Lincoln Property Company Odell School Road Site

For Public Hearing
Petition # 98-46 (C)

Technical Data Sheet

SUBJECT: Administrative Approval for Petition No. 98-46(c) by Lincoln Property Company.

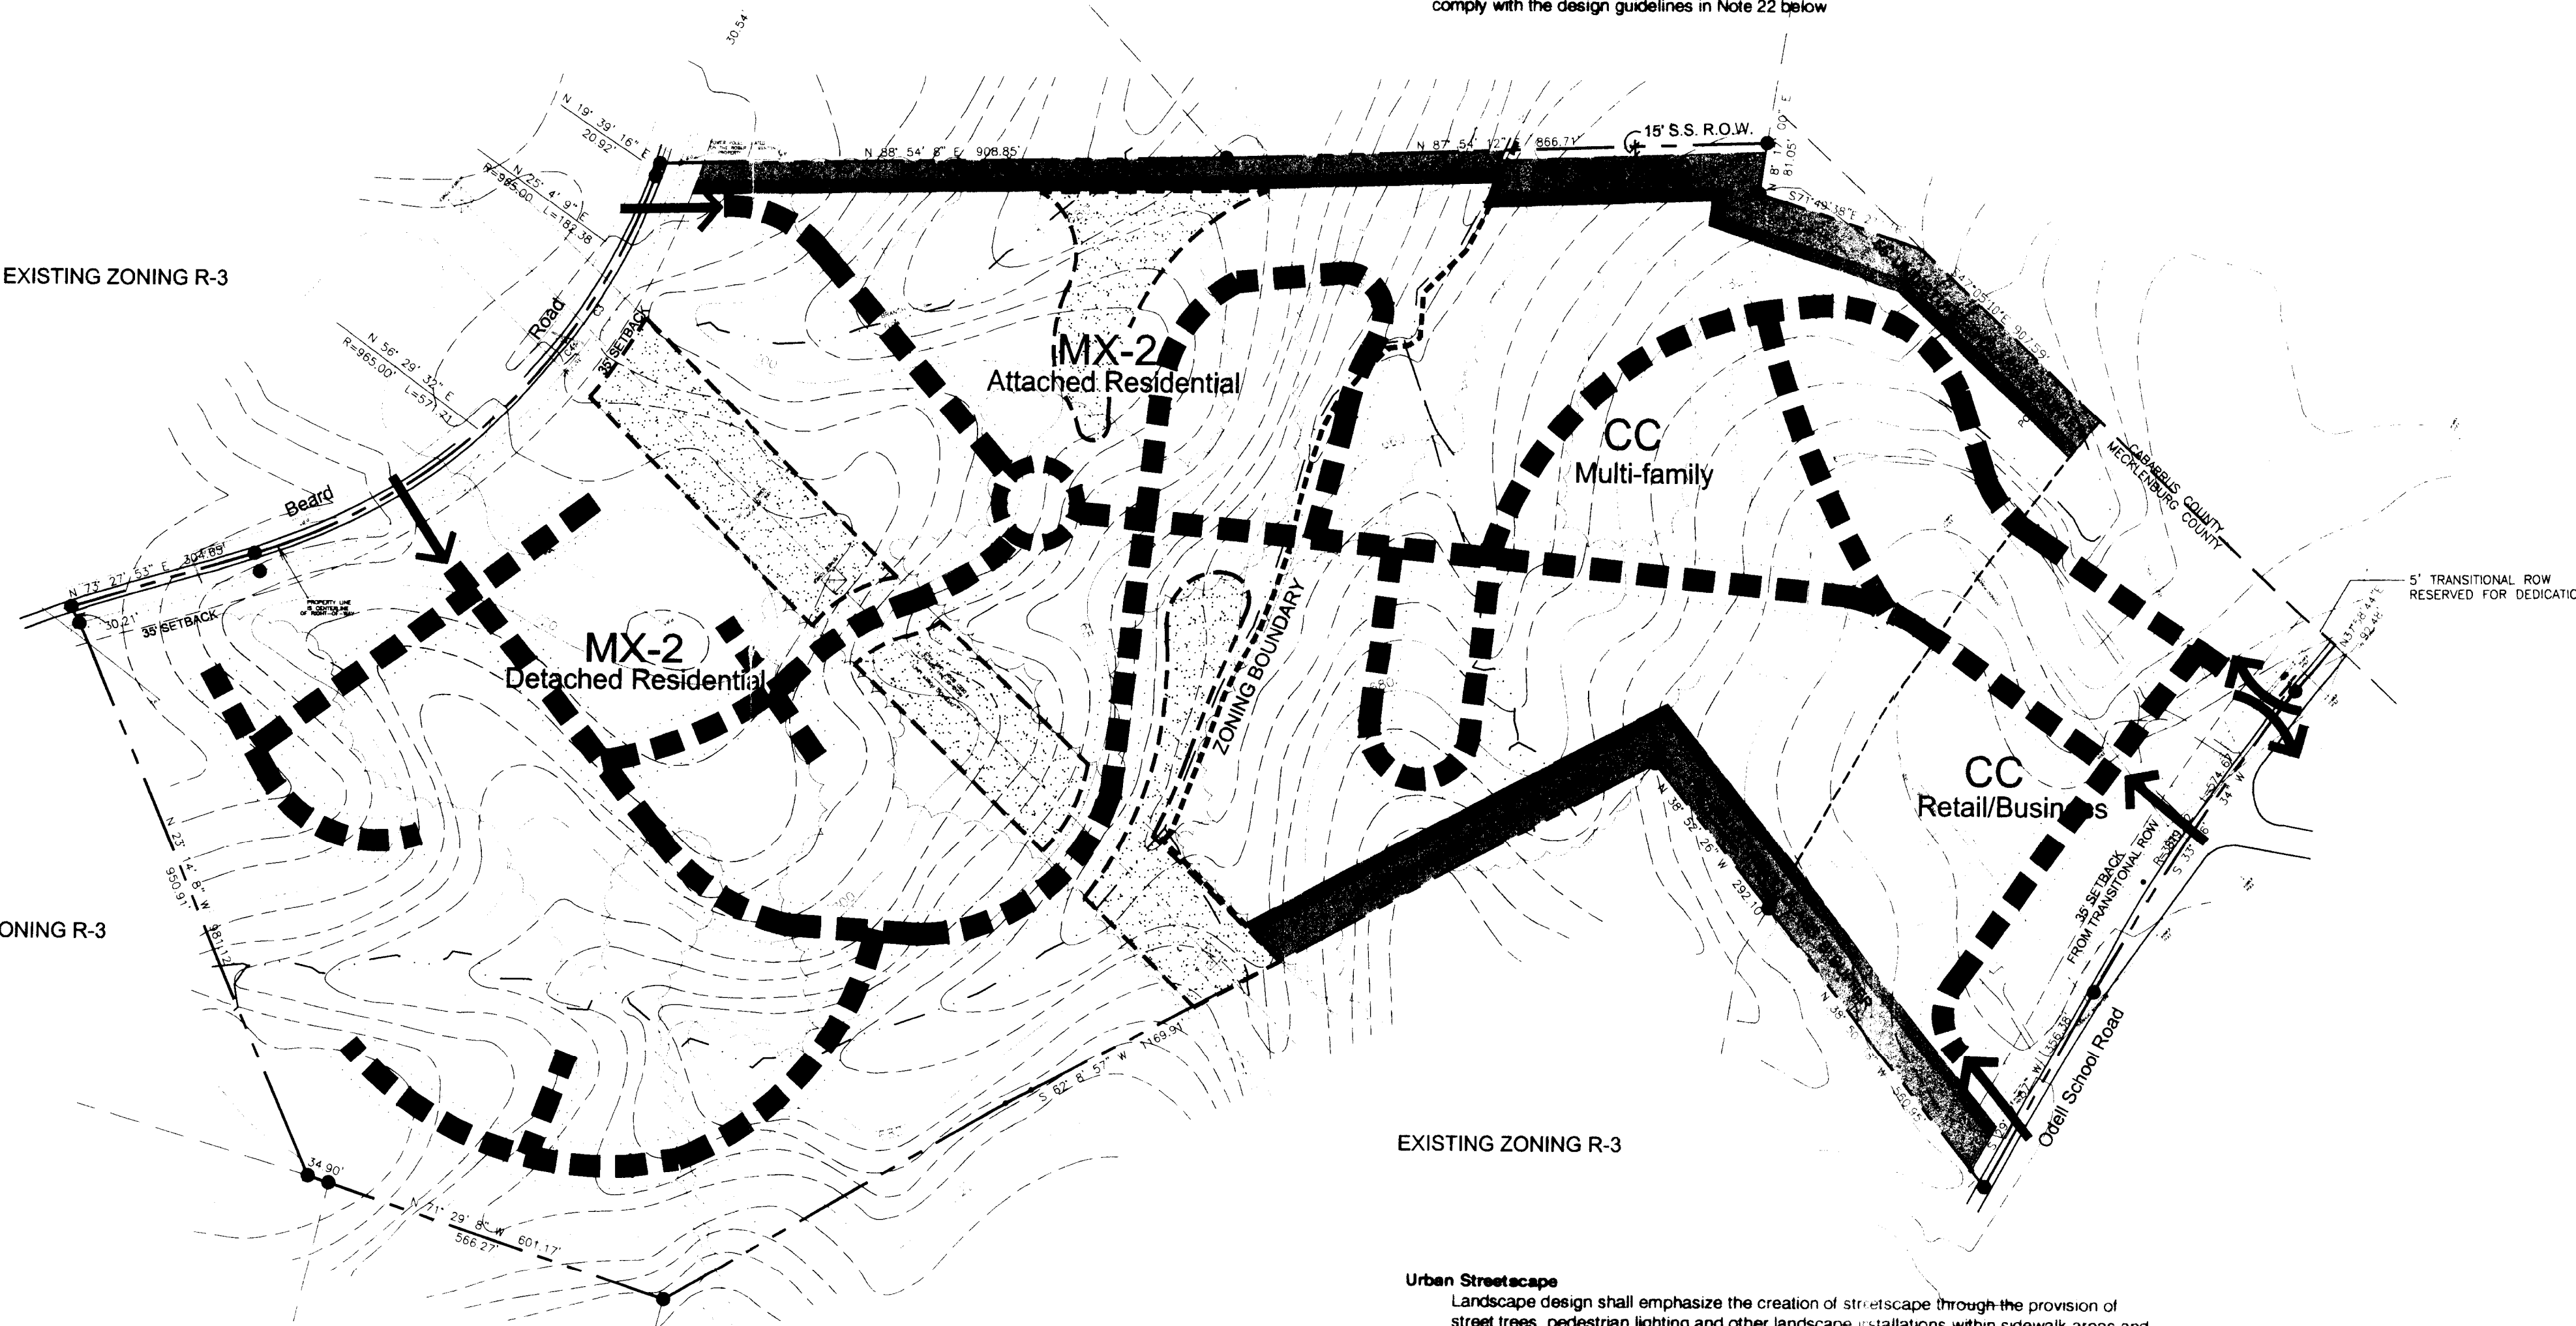
Attached is an erosion control plan for the above rezoning petition. The plan indicates a 40 foot wide area within the 30 foot undisturbed portion of the 50 foot buffer that will be disturbed to allow offsite soil disposal. The plan also includes a cross-section for replanting. Note that a 50 foot buffer is still required along this property line and this plan is only to allow disturbance in the area shown within the 30 foot undisturbed portion as indicated on the rezoning plan. Since this change is minor I am administratively approving this request. Please use this revised plan when evaluating requests for building permits and certificates of occupancy.
